# Urban Design Review Panel Report - Revision 1

## 500 Coventry Road, Ottawa

**RE: Urban Design Review Panel Report – Revision 1  
Site Plan Control Application  
500 Coventry Road, Ottawa**

# Master Plan - PHASE 1

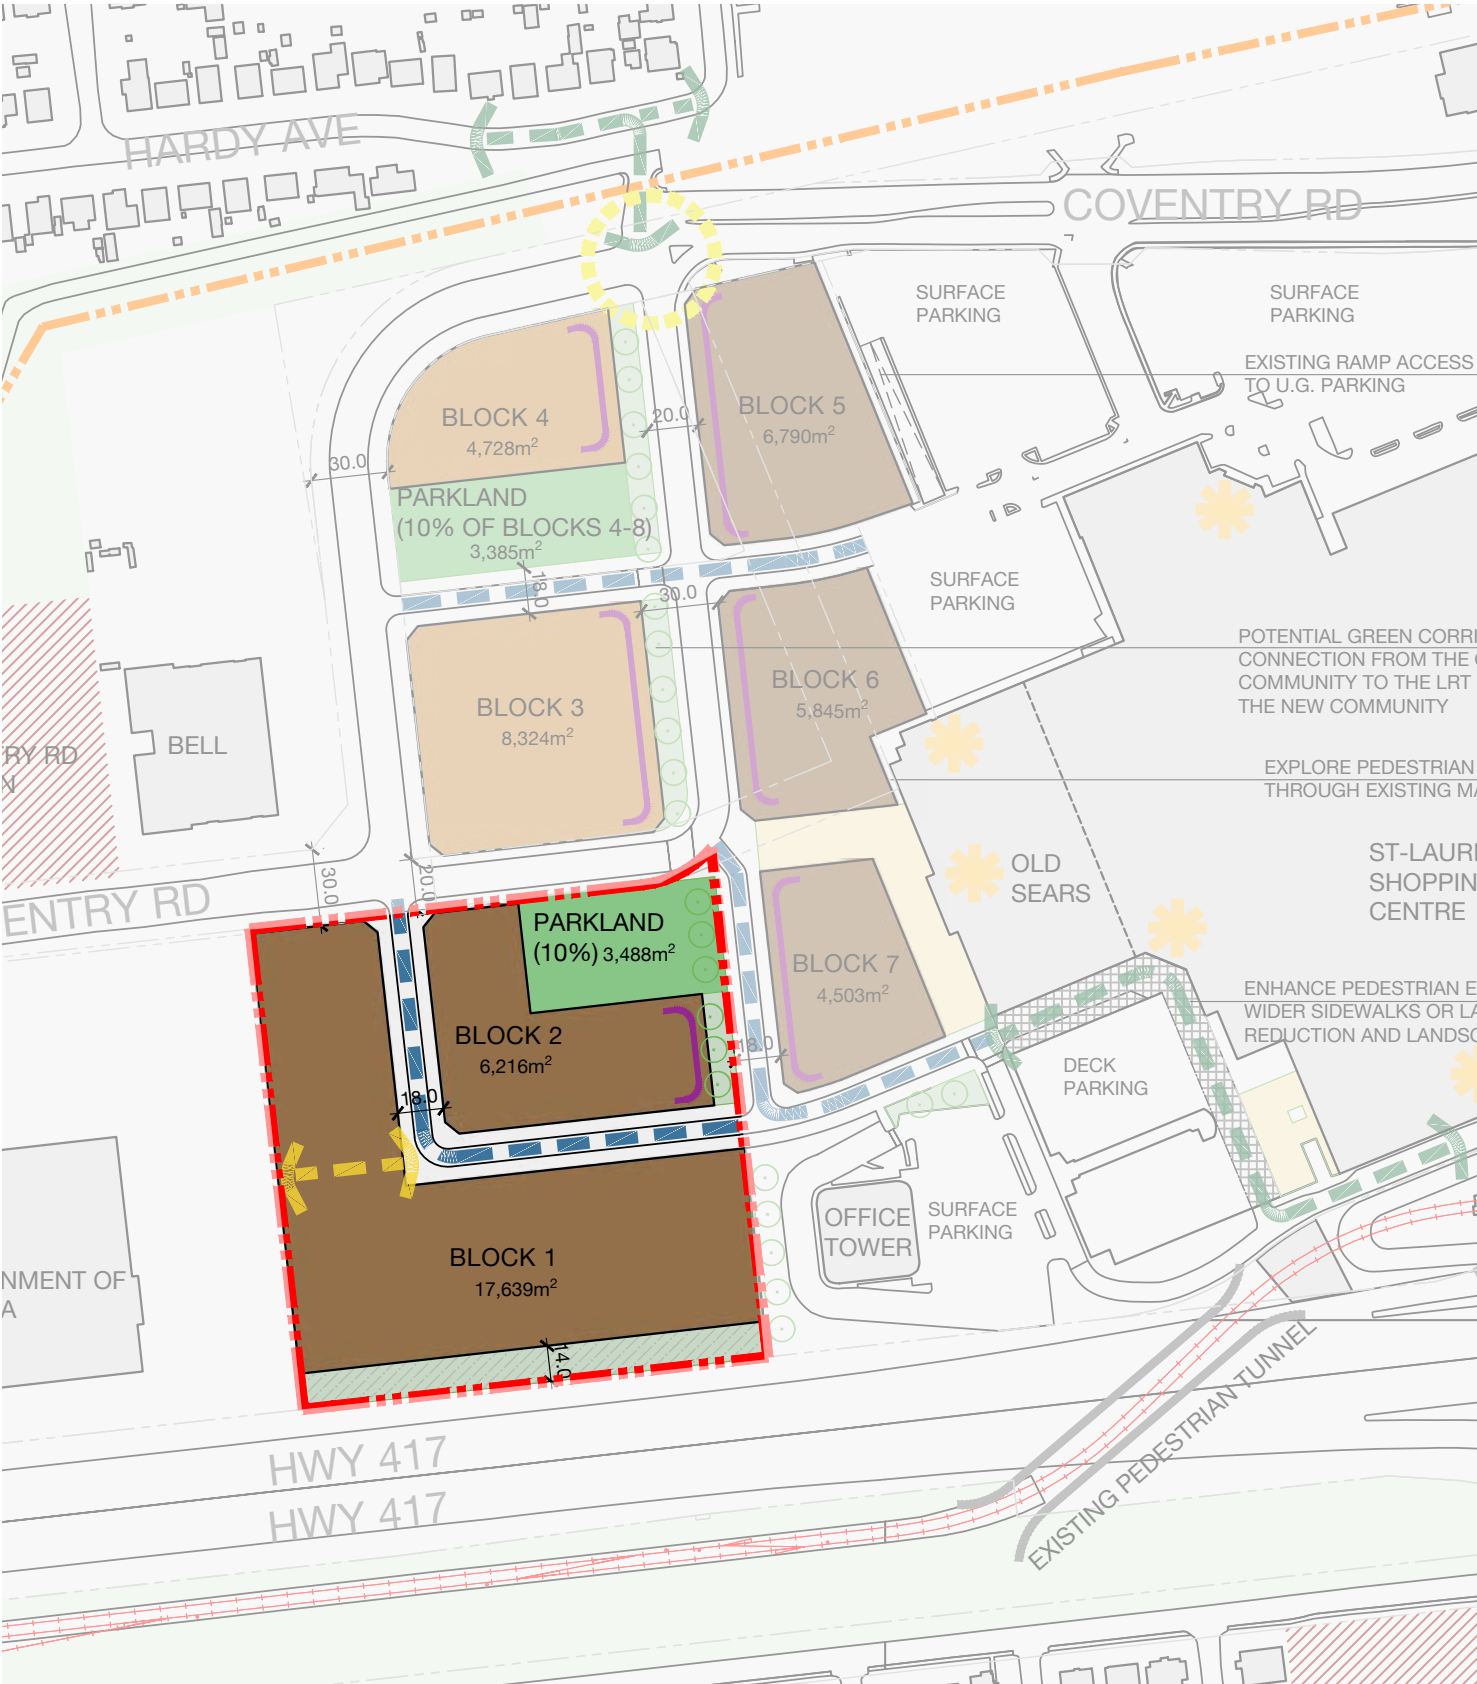
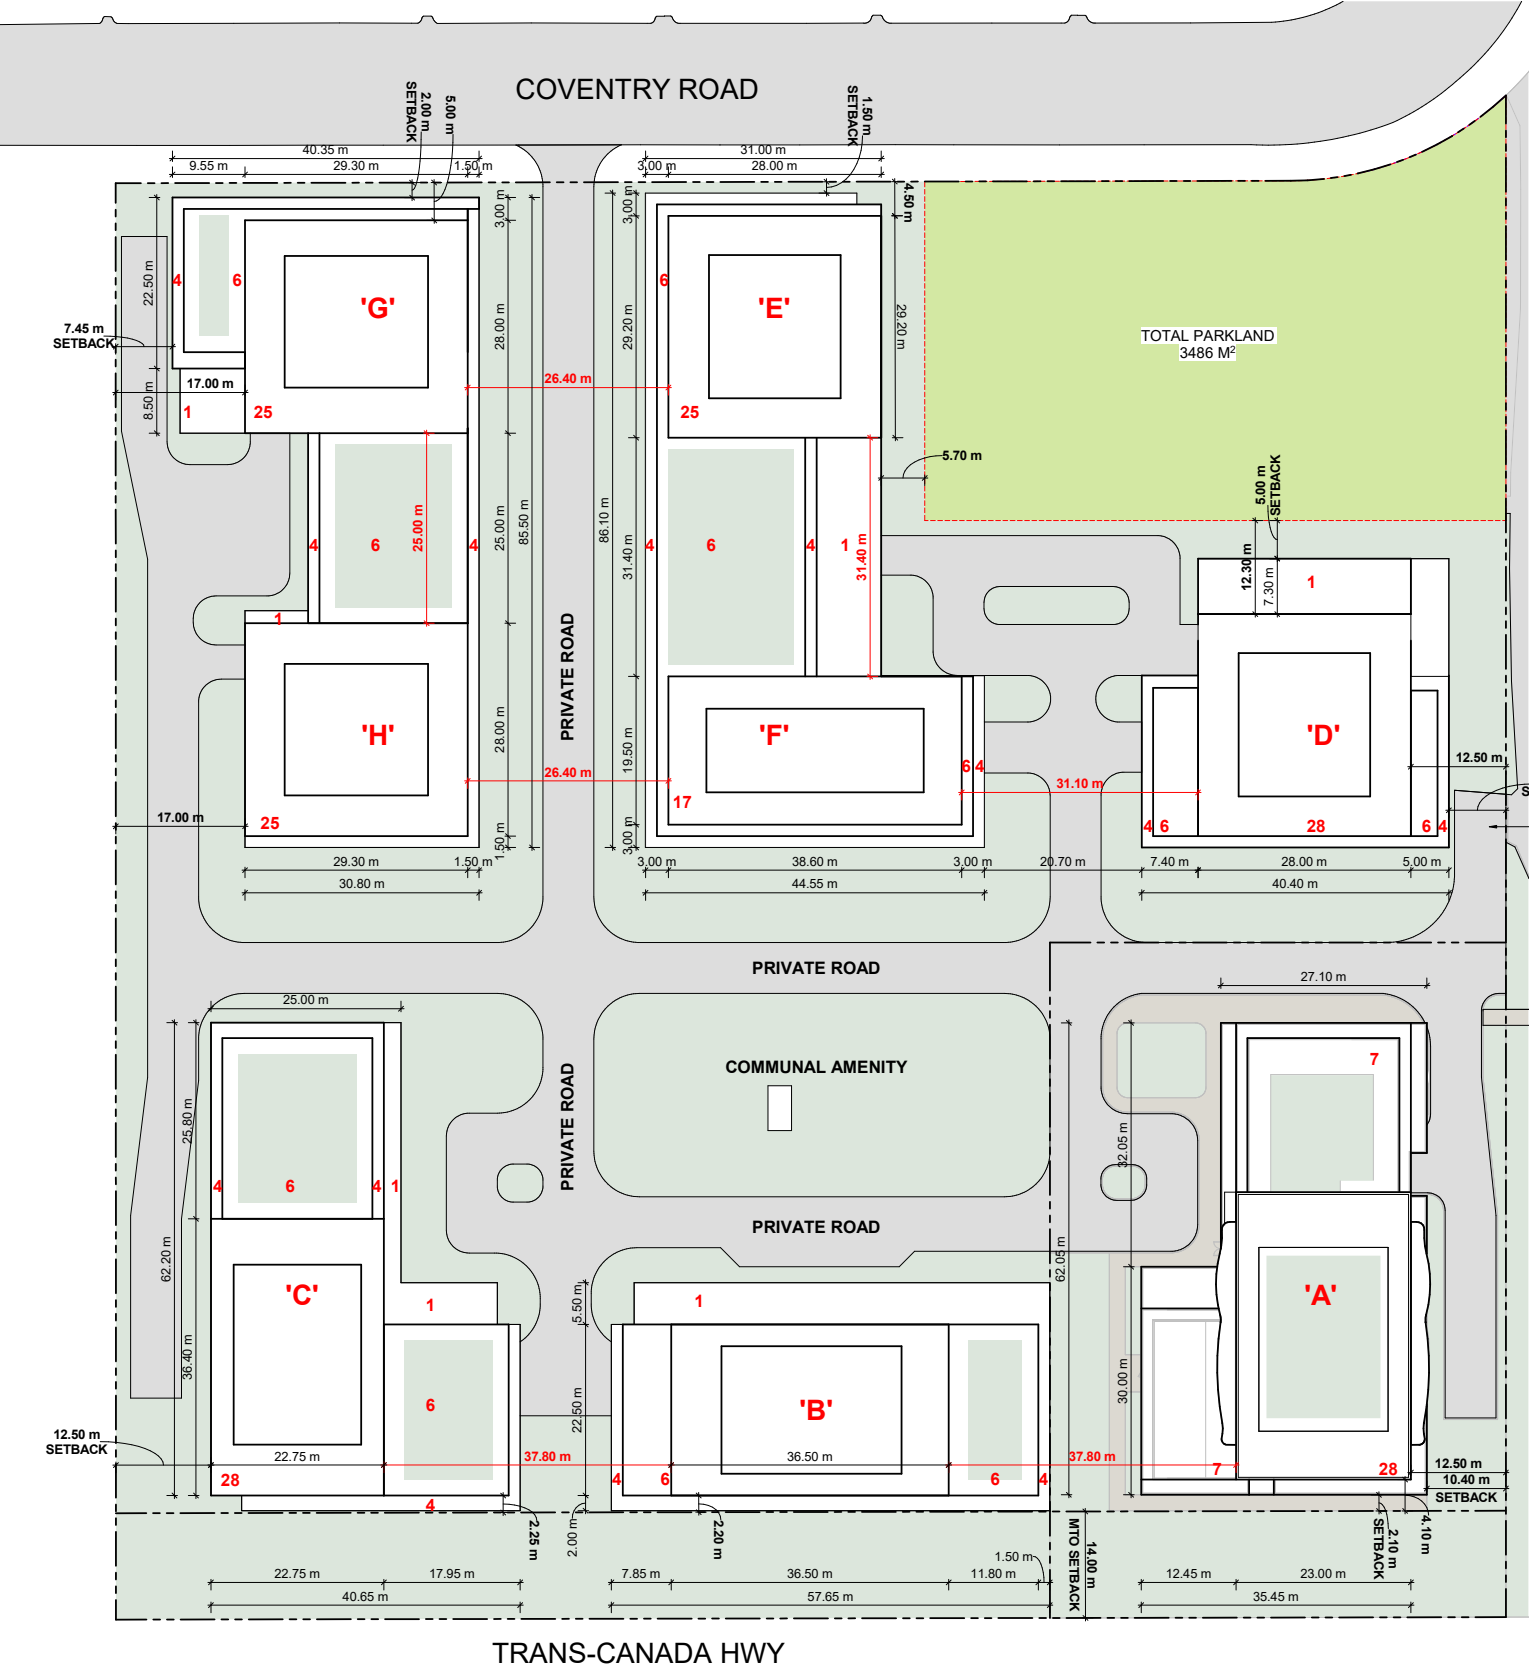
2. The Panel strongly recommends more thought be given to creating a pedestrian-first built environment and layering to the Phase 1 Master Plan presented (p.26), as it currently appears overly vehicle oriented.

18. The Panel has concerns with how vehicle oriented the Phase 1 Master Plan (p.26) appears to be, and strongly recommends the loading and drop-off areas be located closer to the two main private roads. As currently designed, the loading and drop-off areas are too deep into the sites and not optimizing land use for a pedestrian-first environment.

- Consider providing valuable pedestrian mid-block connections and linkages to the mall and park along the east and west edges of the Phase 1 Master Plan (p.26).

- Consider the role of architecture as a terminus/anchor to long views, building on the 'tower in the park' approach to buildings A, B, and C (p.26).

36. The Panel recommends towers A, B, and C (p.26)—the three closest to highway 417—need not be designed in the typical tower-podium relationship/typology.

**Response: Master plan design has been revised to be more pedestrian oriented with less paved road. Refer to sheet SPA005A.**

**Response: Community park and amenity spaces have been thoughtfully integrated into the master plan design, with the intention to active the ground plane and connect buildings. Refer to sheet SPA005A.**
